MIAMI BEACH

PLANNING DEPARTMENT
Staff Report & Recommendation

SUBJECT: **DRB20-0534**
5011 Pine Tree Drive

An application has been filed requesting Design Review Approval for the construction of a new two-story residence and the relocation / renovation of an existing architecturally significant pre-1942 two-story residence and carriage boat house on the subject property including one or more setback and height variances and variances to retain two architecturally significant pre-1942 nonconforming structures.

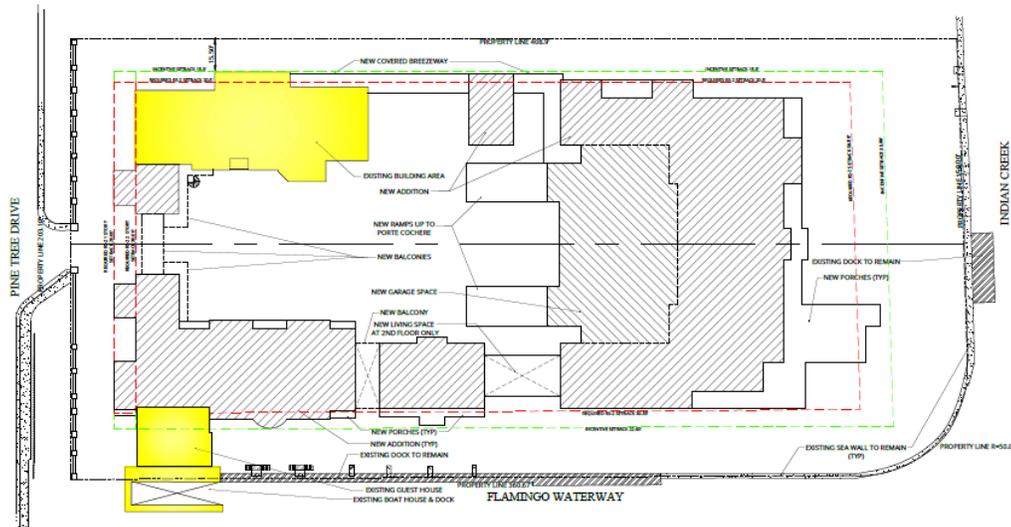
The intent of the new site design is to integrate the main house and the boathouse into the residential complex. The boat house will remain in its current location and the main house will be relocated to a new position along the north property line to allow for the new construction to occupy the former footprint and achieve the vistas of the canals offered from this viewpoint.

In moving the structure, the applicant will rotate the 1927 main structure 90 degrees along the north property line and locate it closer to the front the north property line. The existing building will connect to the new structure at its westernmost point, requiring minimal demolition of a one-story portion of the home that houses the kitchen and laundry.
